Alternate Stormwater Proposal for Williamson Pond

Ian Holyoake. 5 December 2023

Shortfalls and issues I have with the Metis proposal:

001 water depth Williamson Pond.jpg

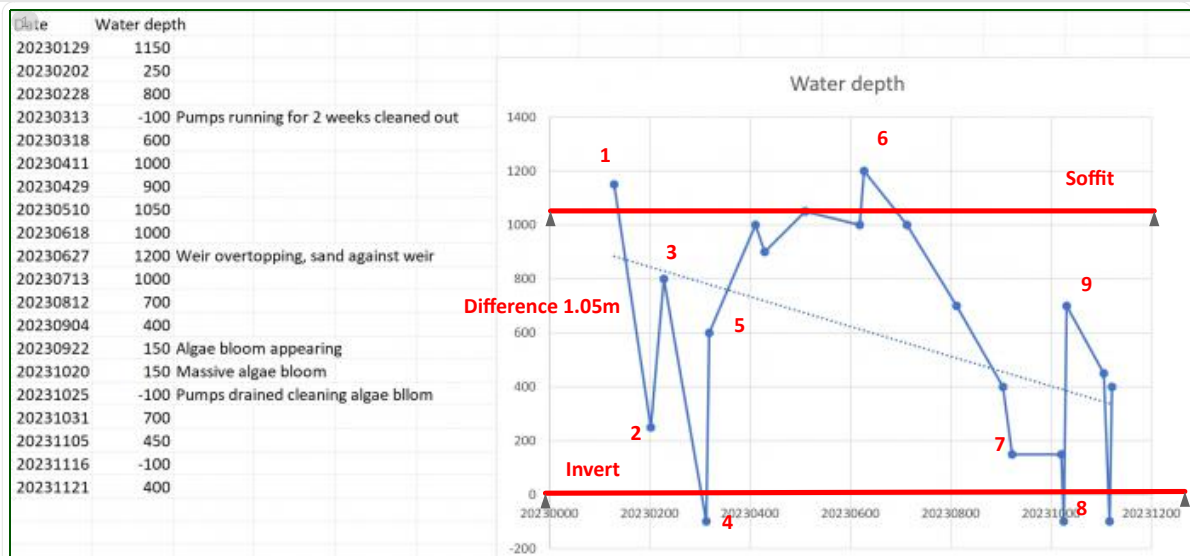
Water Table at Discharge Pipe into Williamson Pond

Data set invert equals 0mm, soffit 1050mm (Metis using Auckland 1946 show my 0 at invert at 2.2mRL)

1. In Hale. Weir over tops at 1100mm
2. Water level drops dramatically as water table around pond is low at summer level
3. Gabrielle raises water level but not to Hale levels. NB: I did not photograph every day. Water level may have over topped the weir.
4. Pumps operated for 2 weeks to lower water level so diggers could clean
5. After diggers water raises back to water table
6. Ongoing rain events continue to raise water levels and weir over tops on a regular basis
7. Water table drops significantly between 27 June 2023 and 22 September 2023. Over the 3 month period water levels dropped 1050mm.
8. Pumps drain lake for second clean and to remove algae bloom
9. Water level rises again and is oscillating - more likely water level in lake rises with each rain event but soaks back into surrounding water table until its crest equalizes.

The trendline (blue dotted line) is the computation of lowering water levels since the cyclone. The water level of the aquifer lags behind the pond water level as the water table fills but once rainfall stops the 2 water levels merge.

I believe the lake level will not drop below mean tide level which must be about -200 below invert.

180 Metis proposal wetland 20231204_235241_SC_.jpg

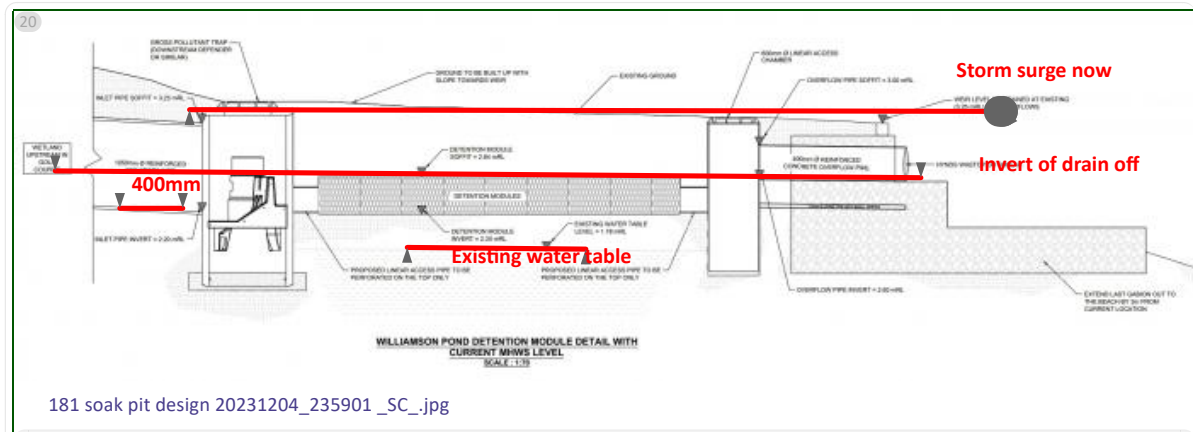
Metis configuration

Issues:

1. The circle represents a gross pollutant trap. It will need servicing so needs to be along Ocean Rd for truck access. Reminder the old sediment trap is along these lines
2. The weir must be raised to prevent surges breaching it
3. The weir must be moved toward the Ocean to change the Vee to stop/minimise surge funnelling
4. The green pipe does not need to be long
5. The pond being changed into wetland is totally unacceptable.
6. The discharge rate other than in storms is only road runoff which is zero in dry weather.
7. Cannot ever have a wetland (or pond) in close proximity to childrens playground.

If council wants a NO then take this concept to the community.

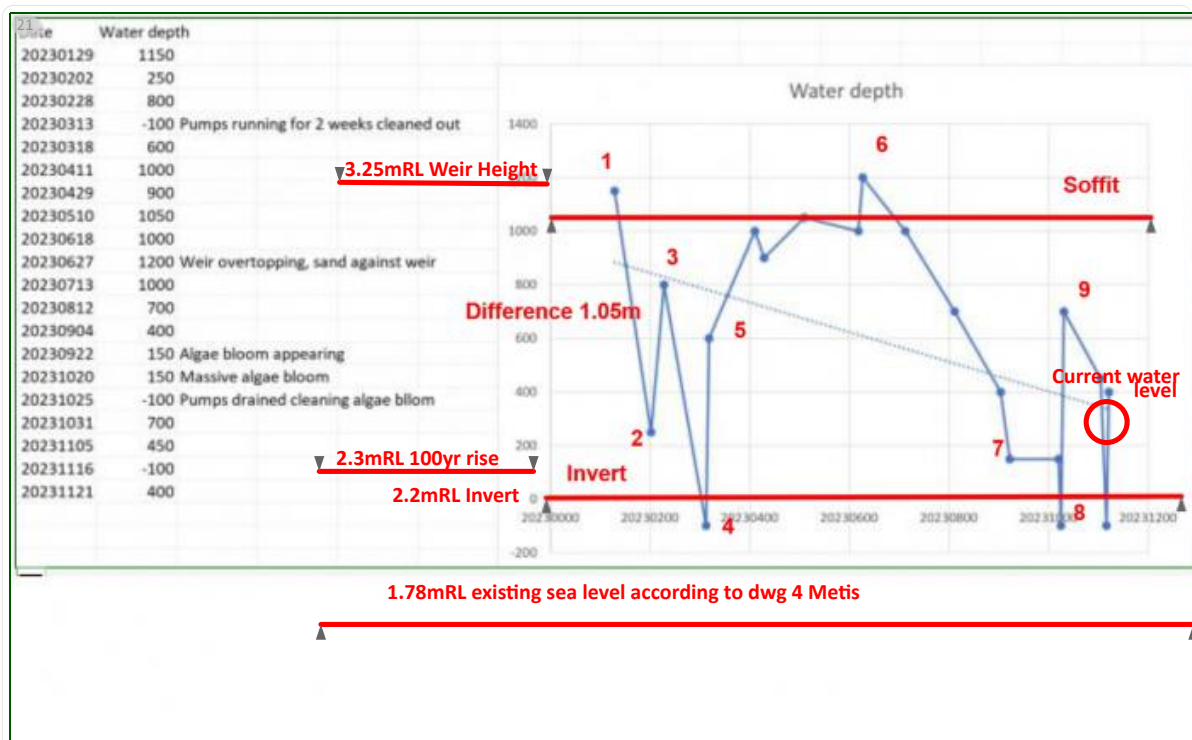
Drawings cannot be right as the drain off level is 2.6mRL and the discharge invert is 2.2mRL which leaves 400mm still water in the Williamson Rd pipe and the Cirtex submerged.

The reservations I have with the Metis design include:

1. Proposal has no storage detention so at high tide the Wastop will shut and the flow rate will continue and breach the Williamson and Ocean Rd cesspits in minutes.

2. The 1050mm Williamson discharge is directed into an unsized perforated tube drawn to about 400mm so won't cope.
3. Overflow relies on the bubble up through the linear access chamber which relies on the perforated pipe flow rate through the Cirtex. This will be inadequate against gravity with the 1050mm discharge.

4. The drain off to the Ocean at 400mm dia is inadequate sizing. Currently the weir over tops to about 100mm across its width.
5. The Cirtex will be submerged and not function as the invert drain off is above this level.

6. The 'existing water table level' at 1.78mRL is well below its current level at about 2.45mRL. Where did this figure come from?
7. The water table rises as rains fall. This means the Cirtex is serving no purpose for extended periods when we need drainoff.

8. The Wastop invert discharge is well below the current level of sand and will remain blocked.
9. Maintenance will be required after every storm, blow, King Tides and storm surges to remove debris, trees, seaweed and sand.

10. It is not a plausible bet or expectation that the outlet flow rate will overcome the debris and sand build up during or after storms.
11. The recent debris build up was not a rainstorm event but low pressure and wind which combined as a storm tide without much rain. This vent would not provide velocity and force to open the Wastop. It will not clear naturally.

12. How will maintenance be done whilst the weather is wild. No machine or operator will be safe during storms.
13. By filling in the basin we lose the storage capacity at high tide. Whilst sand does store water it takes time to absorb at the soakage rate which is a lot less than liquid water mobility. Won't work.
14. Drawing 4 includes lines for the 100year sea level rise - but this is 520mm above current existing water table levels at 1.78mRL which lifts everything up including storm tides and ability for Cirtex to contribute to soakage.
15. The Cirtex will become submerged and block the Williamson feeder just like it is now.
16. The proposal does not provide much benefit to community users of the reserve.

What should be done now is workshop this proposal into something more useful for the Master Plan.

189 1944 arial view of Williamson Park wher the pond is located.jpg

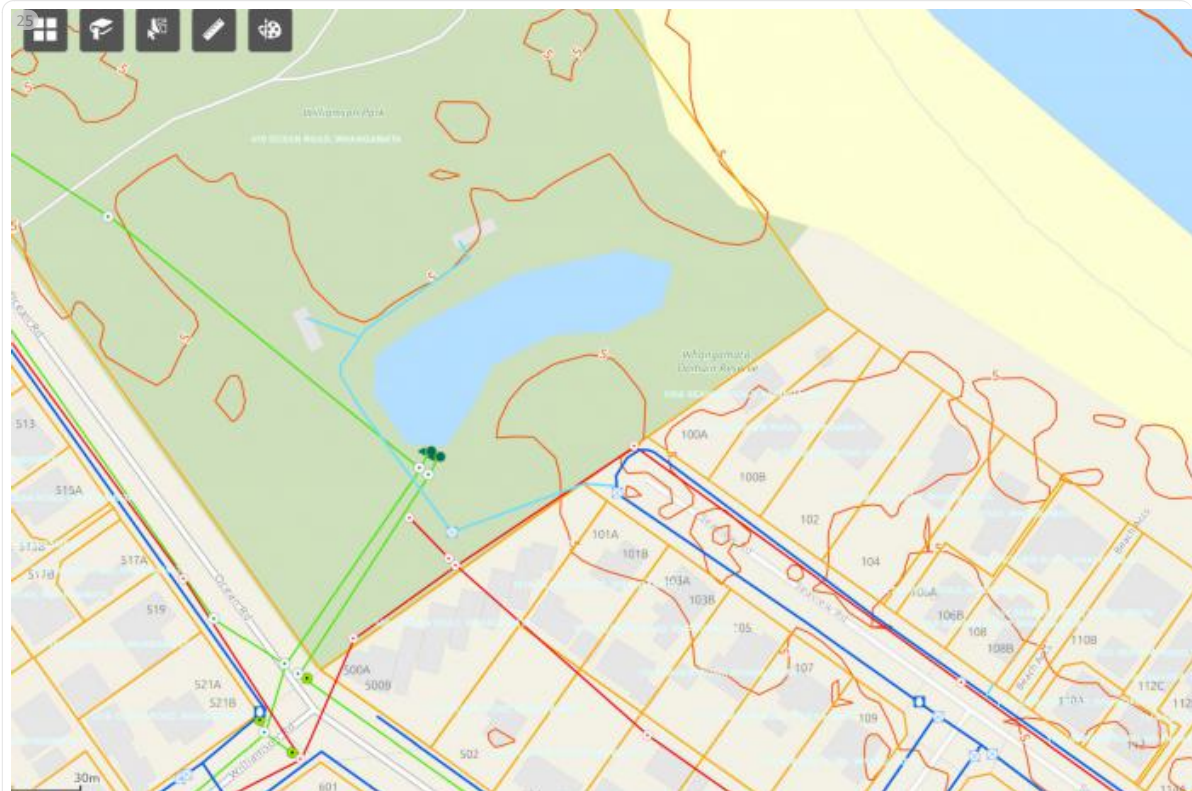
I accept we cannot go back in time but what we can do is remove the bad imprint we have made to date.

Catchment areas must be formed from natural catchment waterways. There is no waterway. There is no overland flow pathway. Everything about Williamson Pond we created to our detriment.

We cannot build-up bad infrastructure. We must reduce its influence gradually until its gone. That is our custodial role.
